El Paso County Parks

Agenda Item Summary Form

Agenda Item Title: Meadowbrook Park Planned Unit Development (PUD) Plan and Preliminary Plan

Meadowbrook Park PUD Development Plan and Preliminary Plan Review

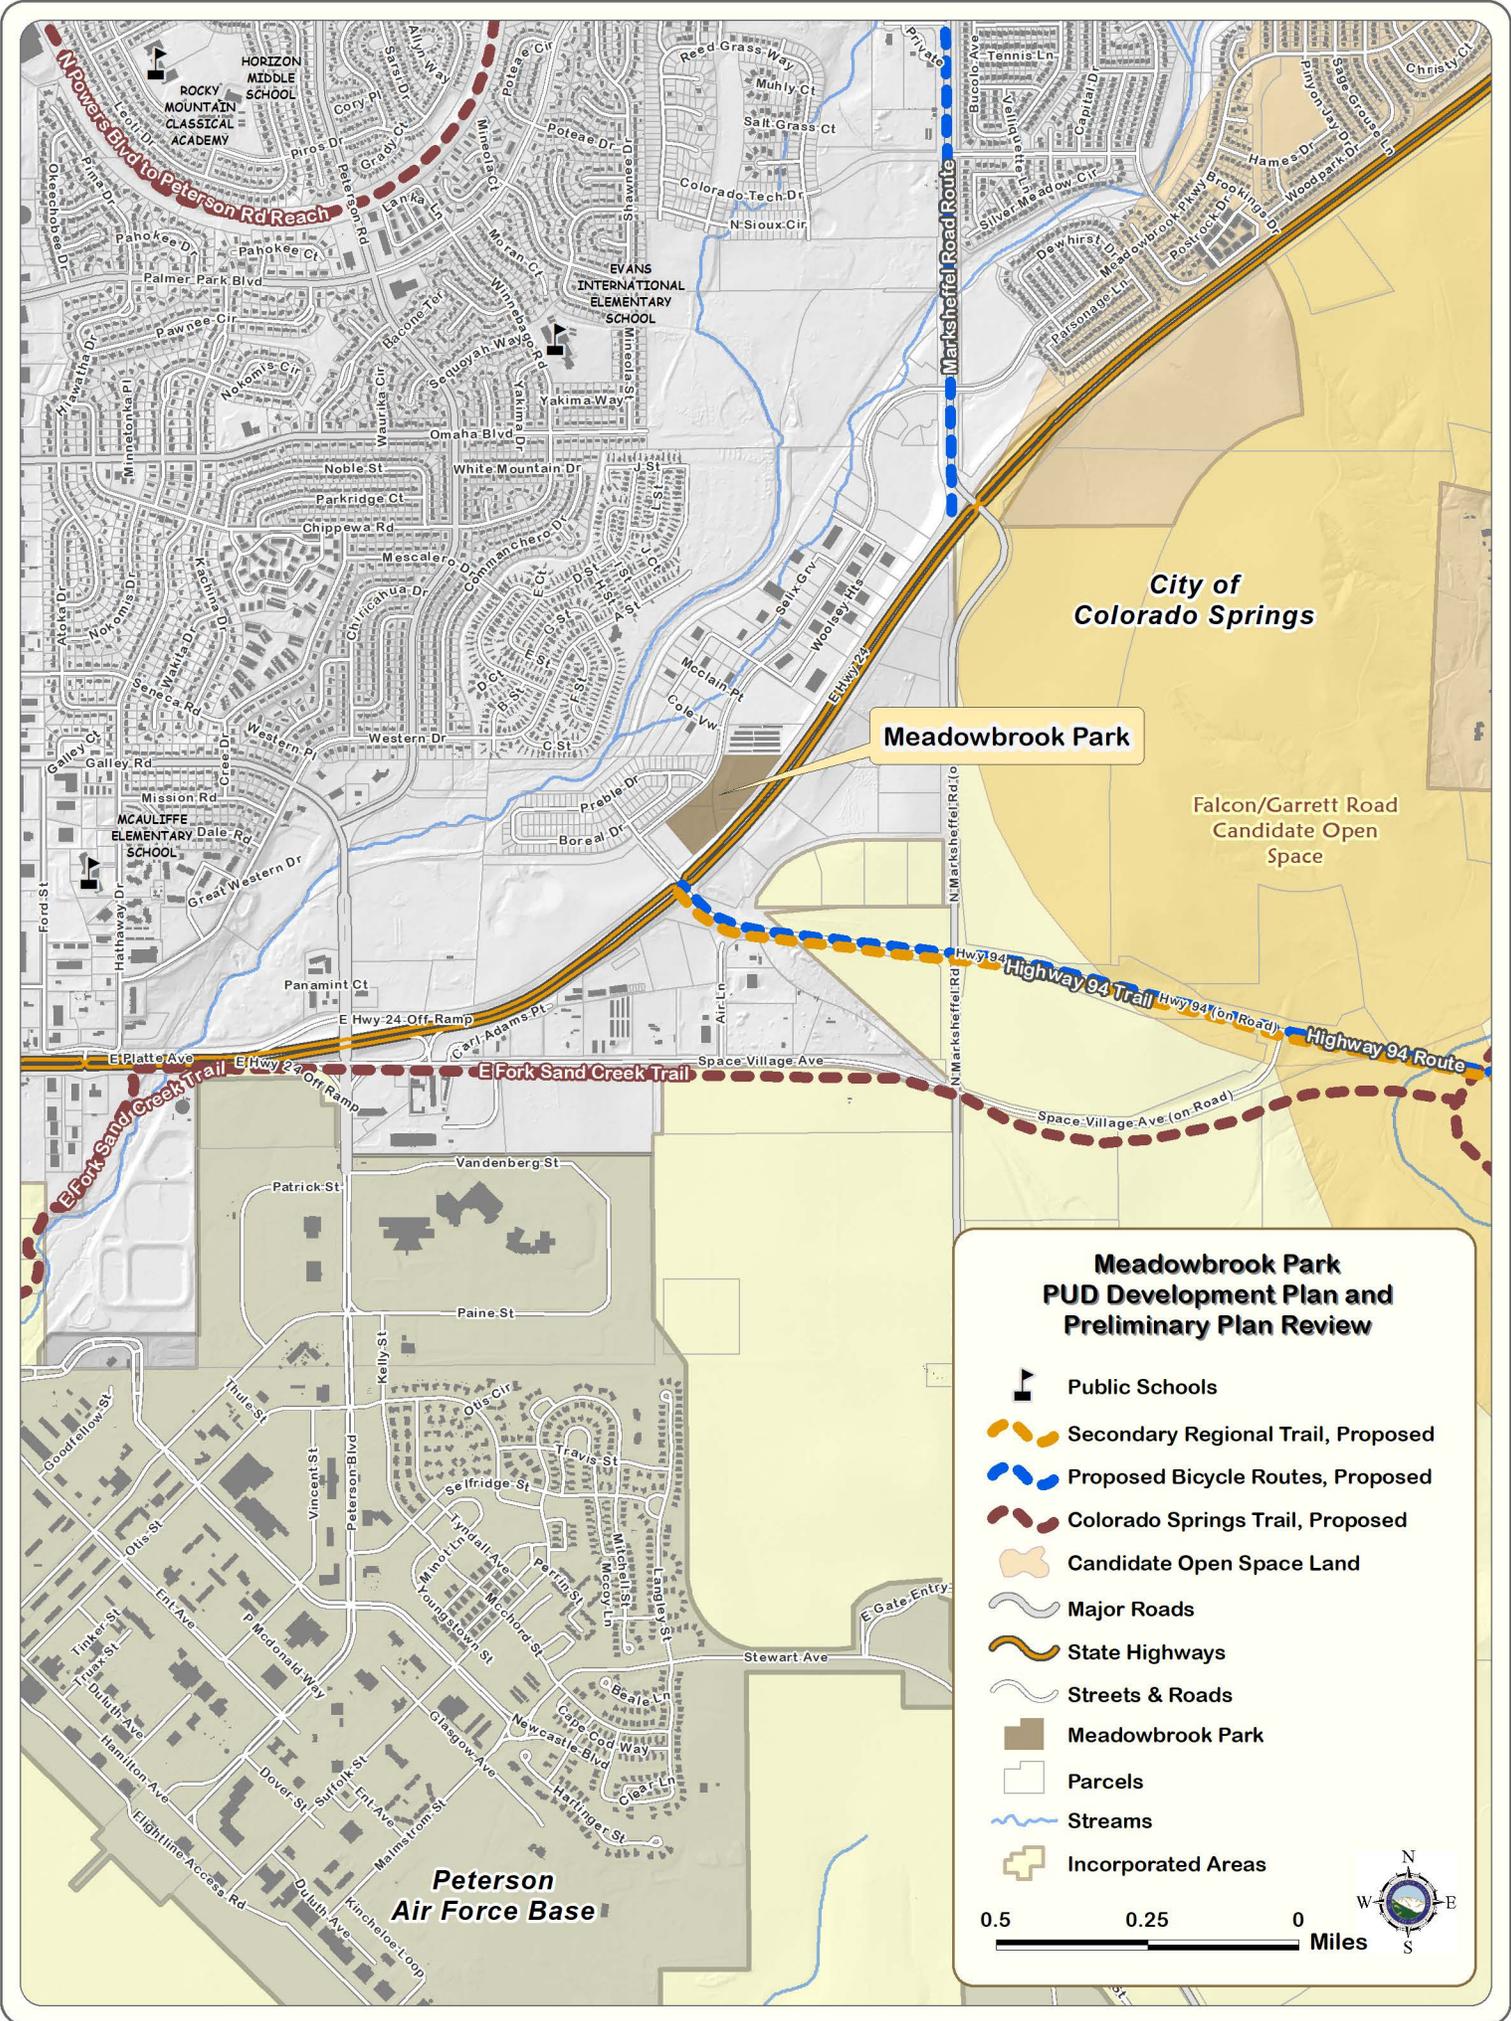
- Section 4.2.6 of the LDC states that “*Constructed storm water facilities may be included in the open space calculation if comprising less than 10% of the required open space, recreational areas, trails and greenways.*”
- Section 4.2.6 of the LDC states that “Open space shall be concentrated in large usable areas. No less than 25% of the gross land area of the open space shall be contiguous and useable.”

A stormwater detention facility, comprising 0.37 acres, or 19% of the 1.949 acres of open space, occupies a large area in two of the open space tracts, Tracts A and F. The remaining 1.58 acres, or nearly 20% of the overall project area, is located in the remaining sections of Tracts A, C, and G, and is shown to be contiguous and usable. While the inclusion of the stormwater facility in the open space calculations is not allowed under the provisions of the Land Development Code, the removal of the stormwater detention facility acreage does not place the development below the required 10% open space requirement.

The Park Advisory Board recommends that the Planning Commission and the Board of County Commissioners include the following conditions when considering and/or approving the Meadowbrook Park Planned Unit Development Plan and Preliminary Plan: 1) per the El Paso County Land Development Code, remove the stormwater detention facility from Tract A and recalculate the open space acreage; 2) include descriptions and drawings of the two neighborhood pocket parks in the Letter of Intent and PUD Plan and Preliminary Plans, respectively; 3) fees in lieu of land dedication for regional park purposes in the amount of \$32,690 and urban park fees in the amount of \$20,650 will be required upon recording of the forthcoming final plat(s). A Park Lands Agreement may be an acceptable alternative to urban park fees, provided the agreement is approved by the County and executed prior to recording the forthcoming final plat(s).
